**Sent:** 9/03/2020 4:14:58 PM  
**Subject:** Letter of Objection - Application No DA2020/0116  
**Attachments:** Letter of Objection - 129 Upper Clontarf Street Seaforth.pdf;

**Re: 129 Upper Clontarf Street Seaforth - DA 2020/0116  
Proposed Alterations and additions - Construction of a Pool and  
ancillary works**

**View from the neighbour's rear yard of the subject dwelling**

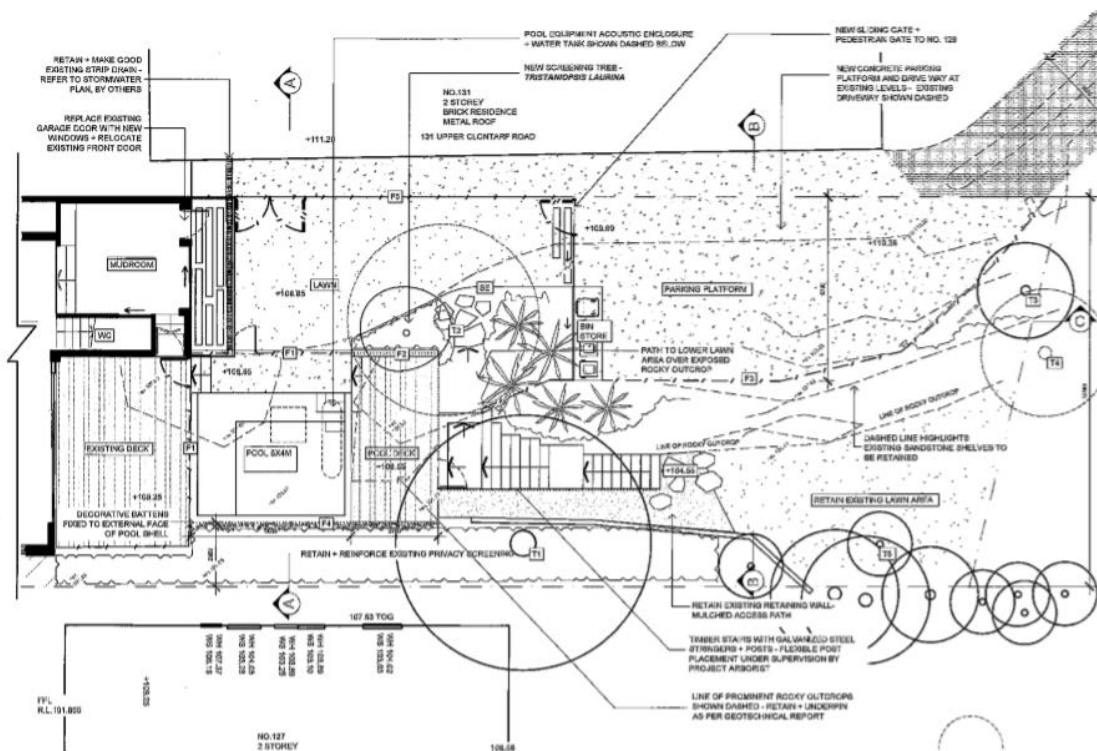
The land forward of this dwelling has an appreciable cross fall to the south by up to 6m over a site width of 12.5m.

An array of vegetation exists within this front setback inclusive of rock outcrops. Formal drainage of the property is not known.

No 127 Clontarf Street is situated on the southern side and sits directly below the subject property. The existing dwelling on the subject property effectively towers over the adjoining southern property.

Overshadowing and building bulk are present issues to the adjoining owners.

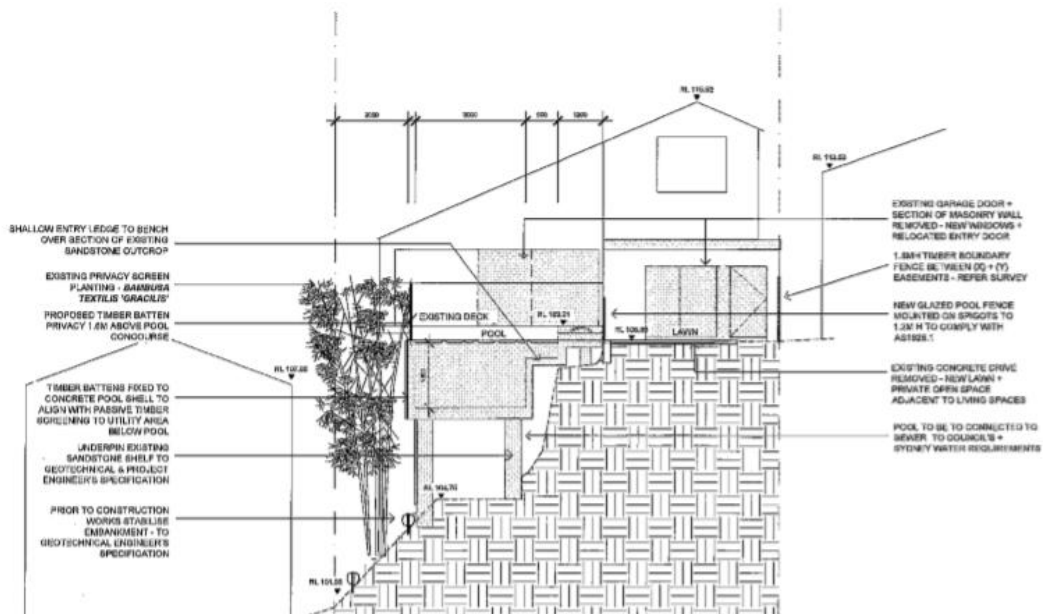
Of particular, relevance to the adjoining owner is the proposed construction of a swimming pool described as being partially above ground adjacent to the existing deck.

Also proposed are new steel/timber pool deck + steps to access lower lawn areas and storage below the dwelling/proposed pool. (quotes extracted from the statement of environmental effects).

The proposed pool is to be built above an existing outcrop with a maximum height to the coping of approximately 4.5m at a setback from the southern side boundary of 2m. The proposed access stairs to the pool deck and proposed retaining walls are also located near the southern side boundary.
